**TOWN OF FRANKLIN
PENDLETON COUNTY, WEST VIRGINIA**

CONTRACT 1: WATER TREATMENT SYTEM IMPROVEMENTS

ADDENDUM #1

THRASHER PROJECT #D10-11026.00 (Dunn 1901)

DRAWN BY: DR CHECKED BY: E.T.H. DRAWING 1901
SCALE: AS SHOWN DATE: DEC. 2022 **9H**

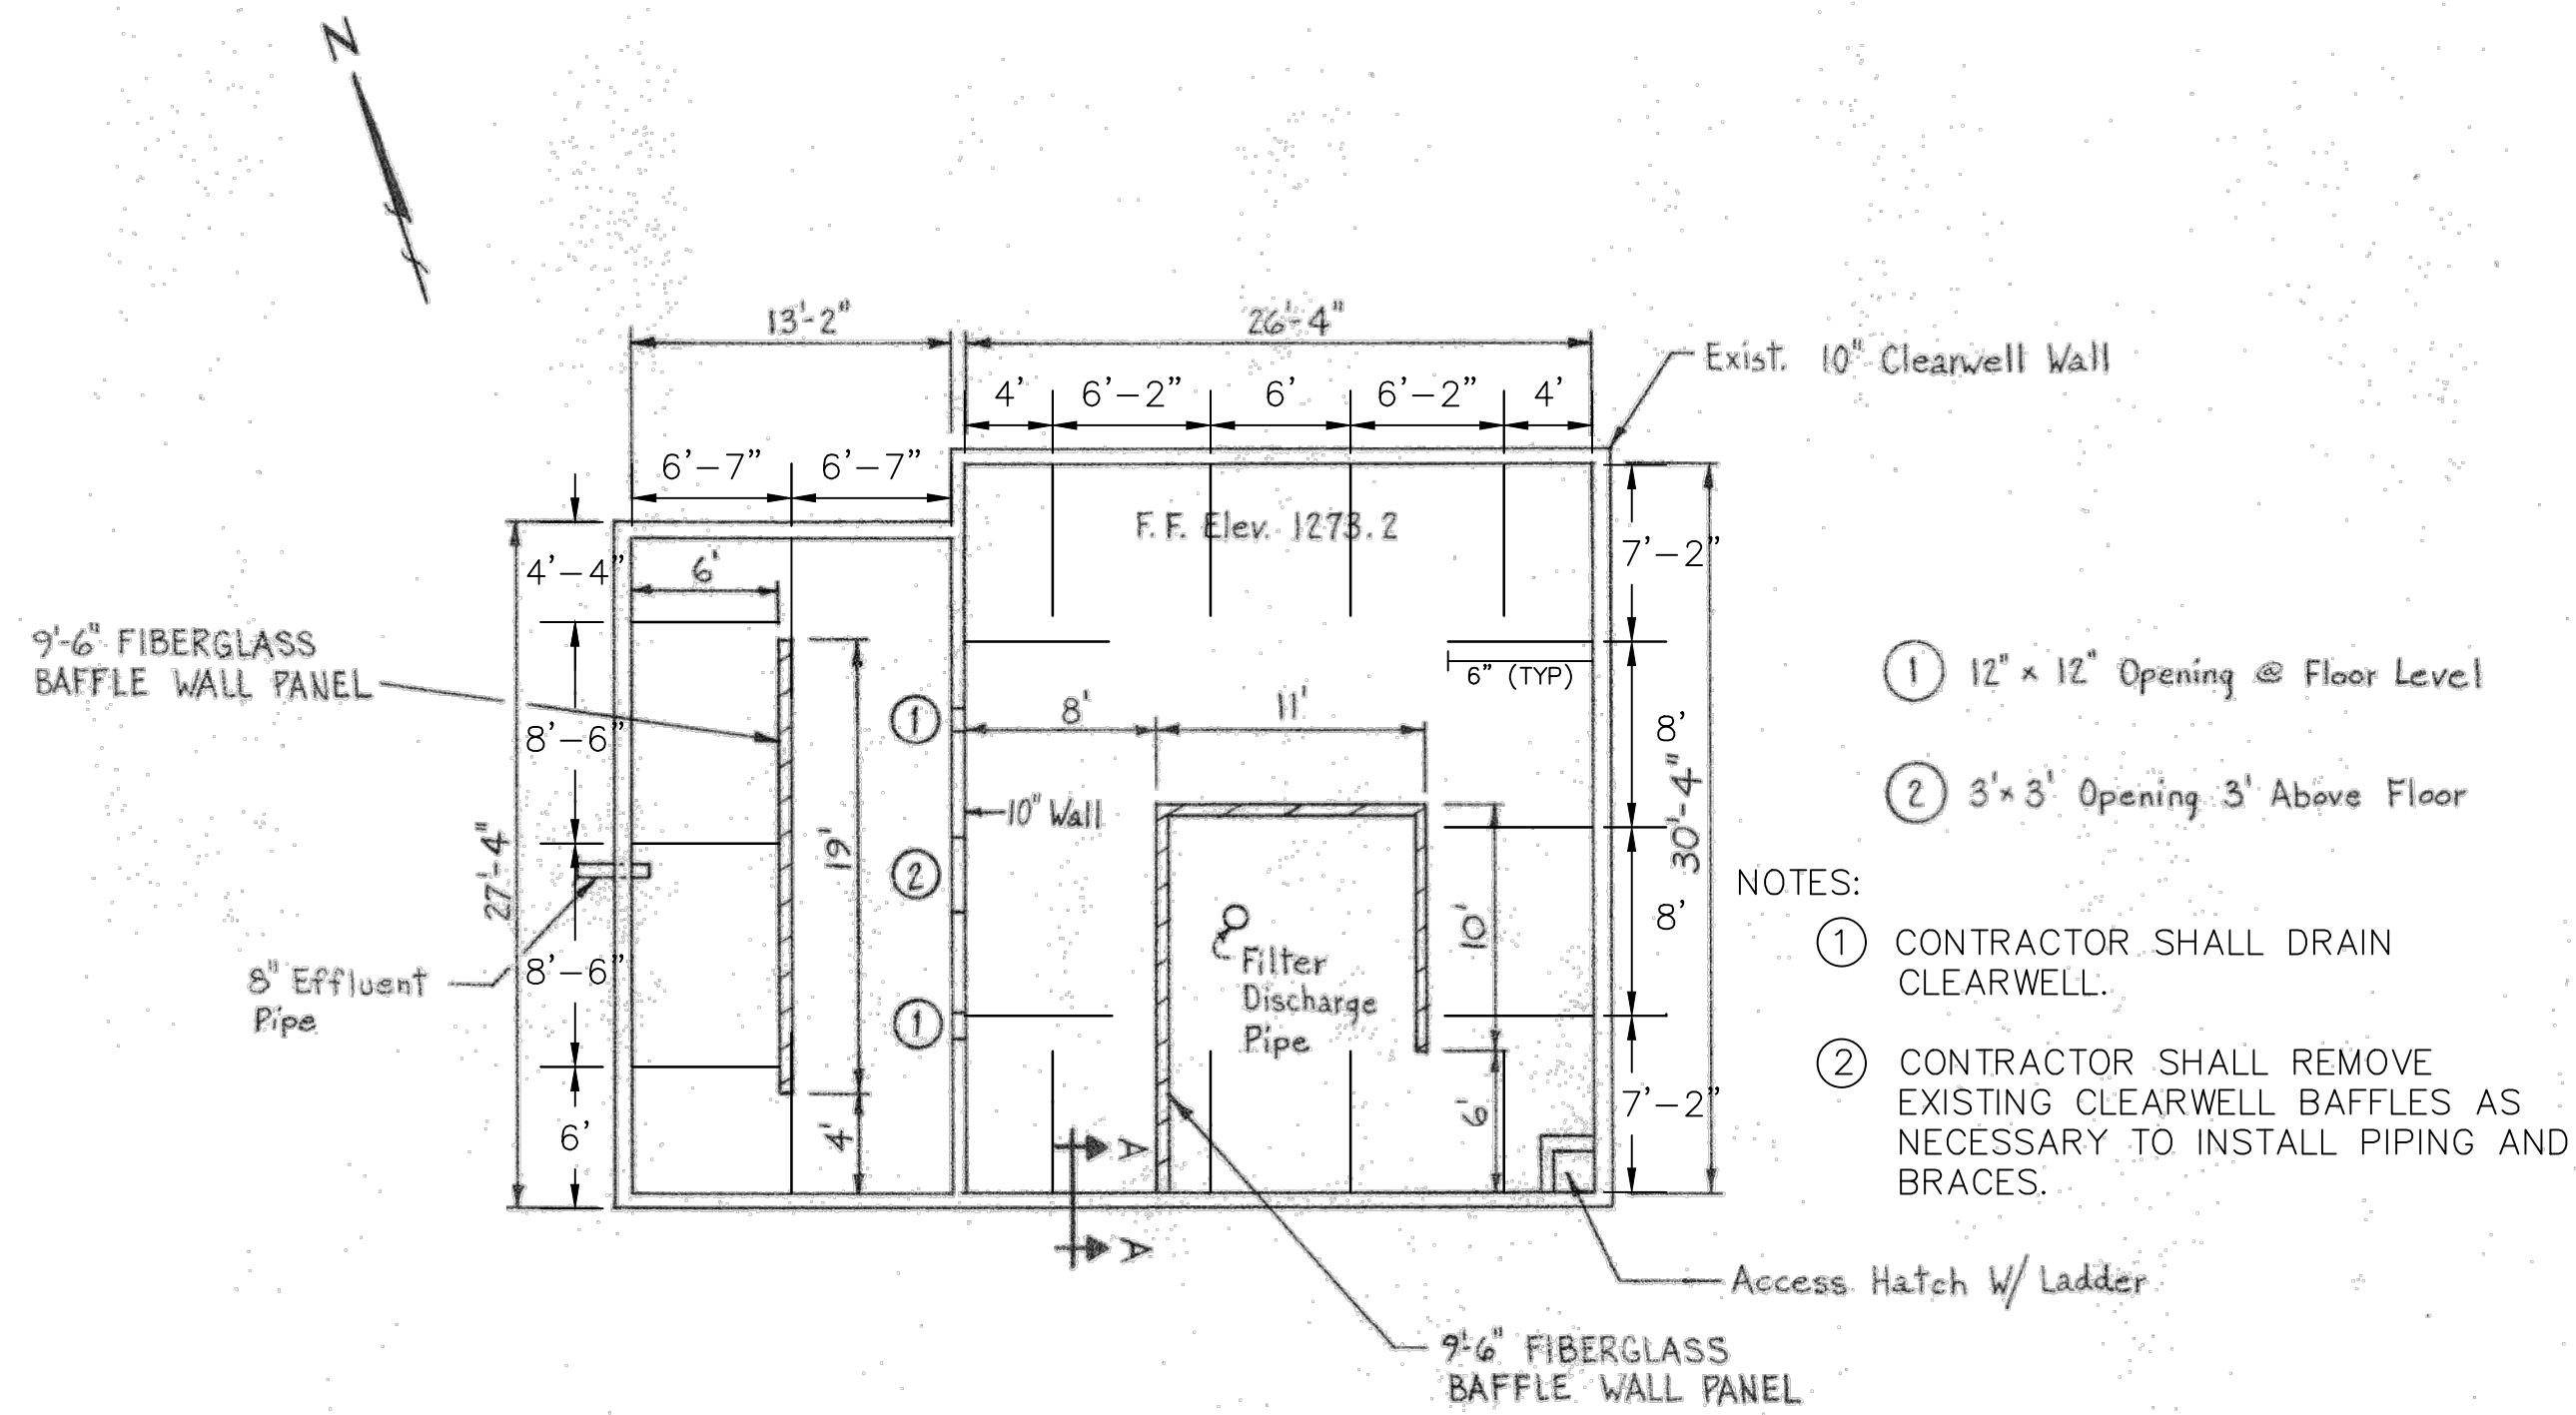
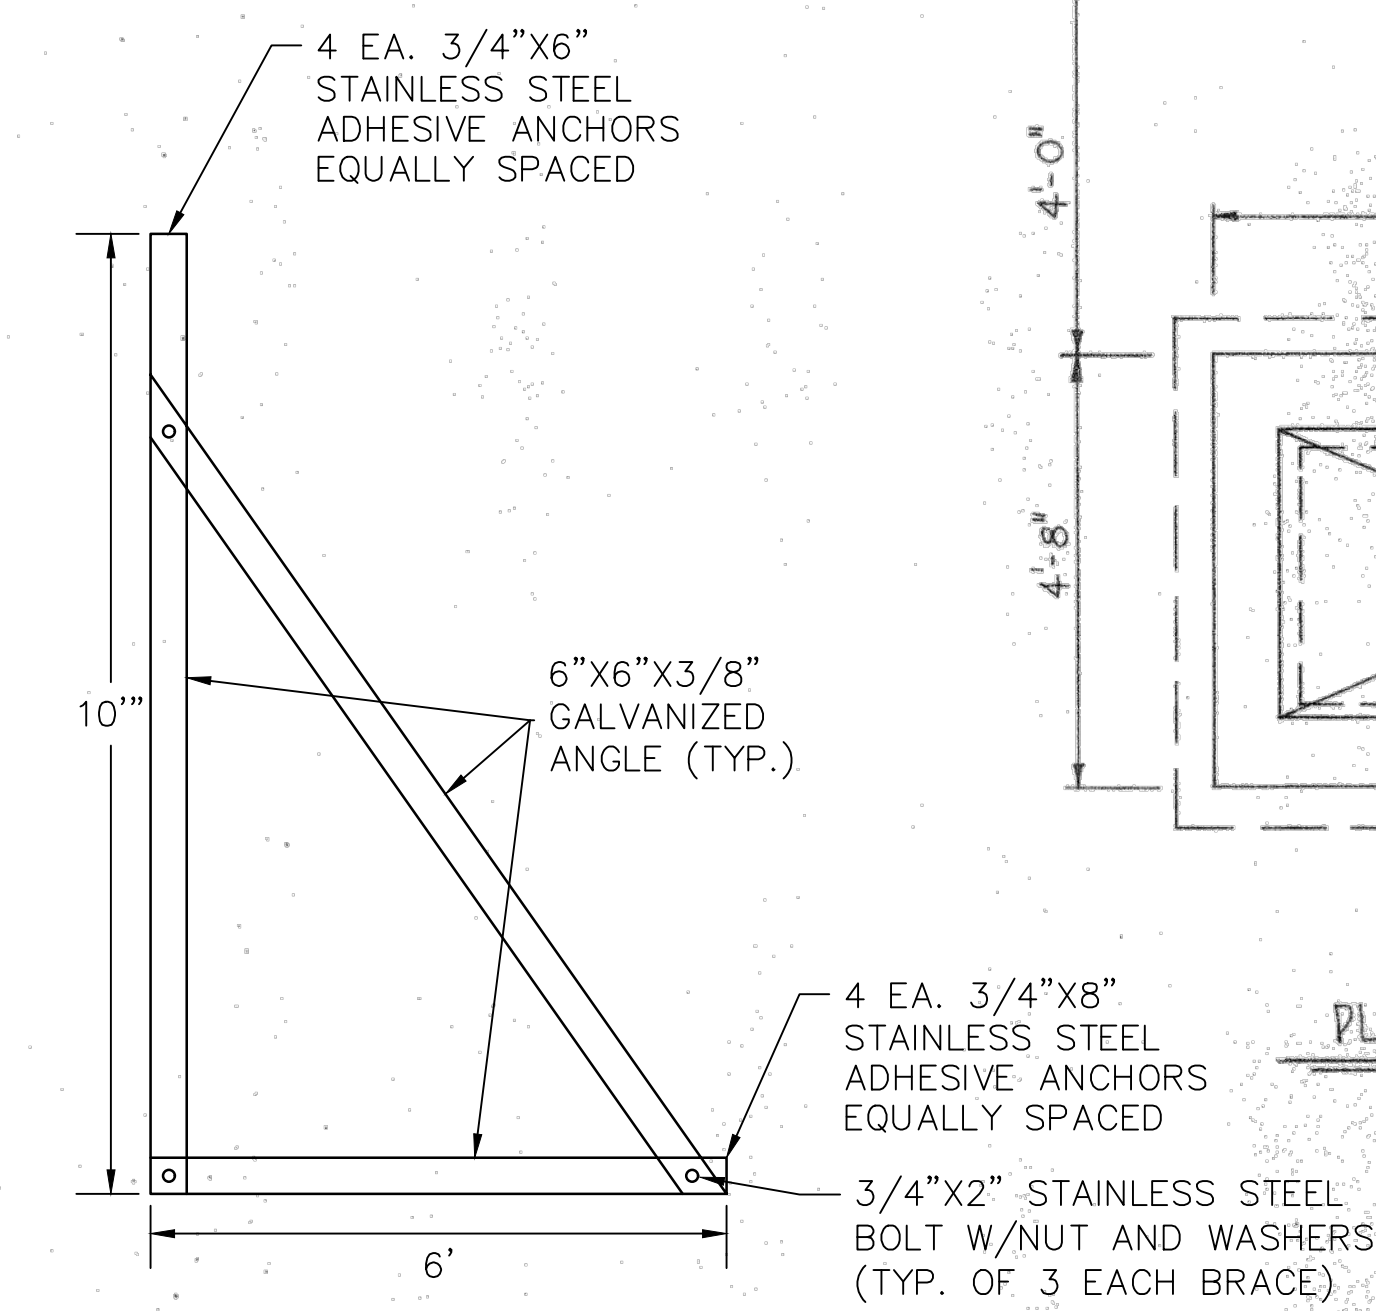
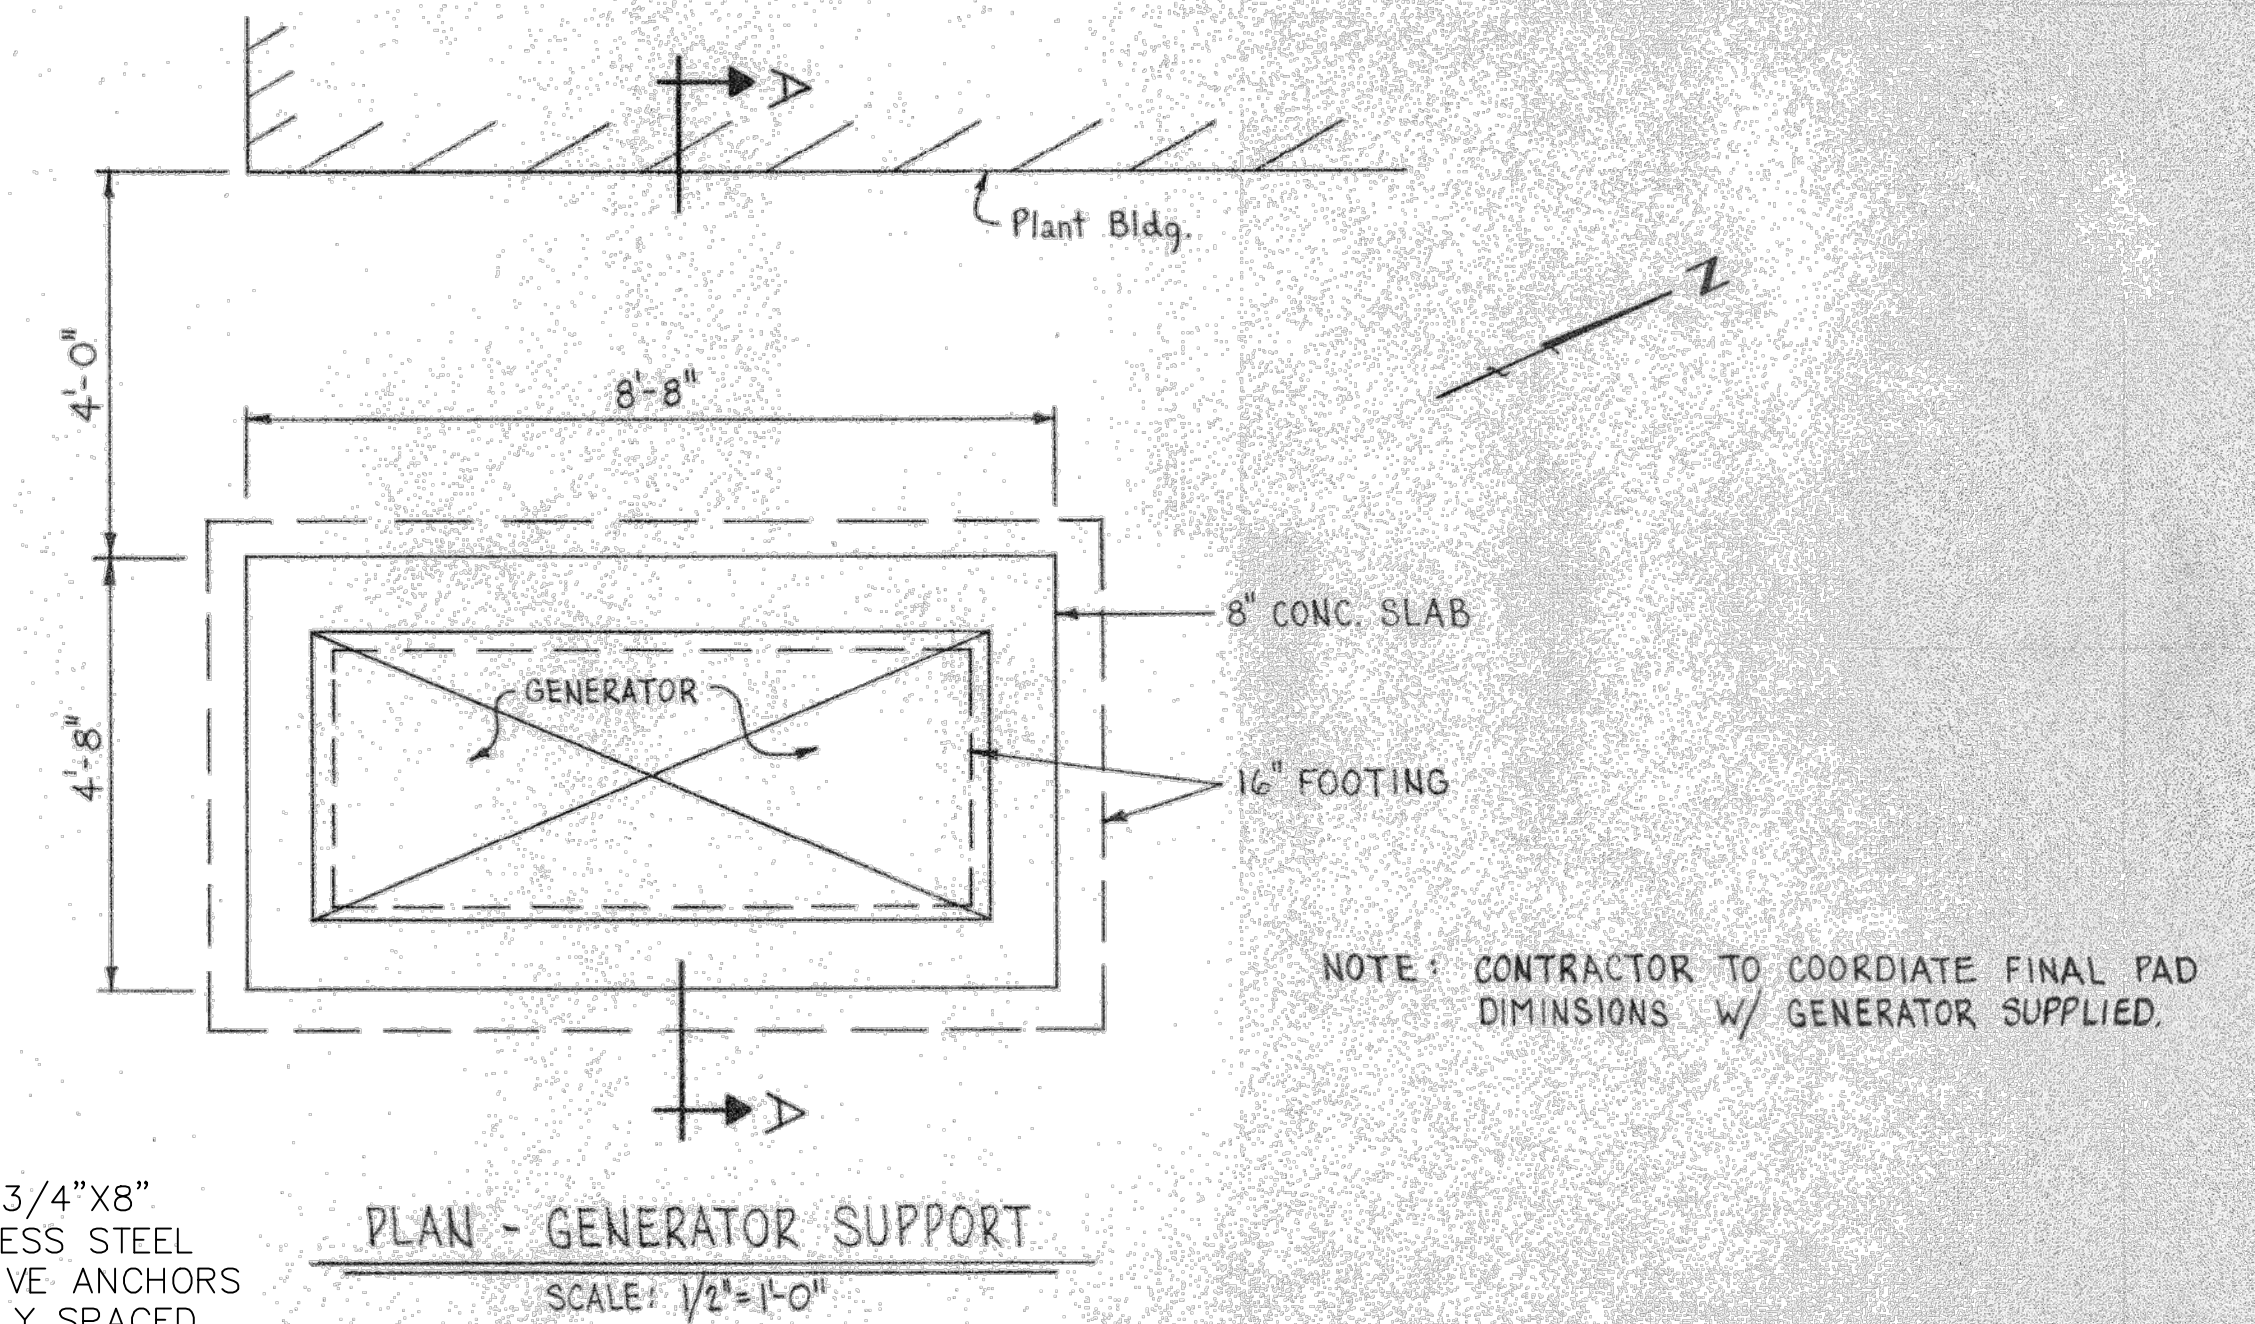
ADD Drawing 1901- 9H CLEARWELL BAFFLE AND GENERATOR PAD

18. Can we use Fiberglass Baffles in lieu of HDPE for the Clearwells?

Fiberglass Panels that are NSF61 approved may be used.
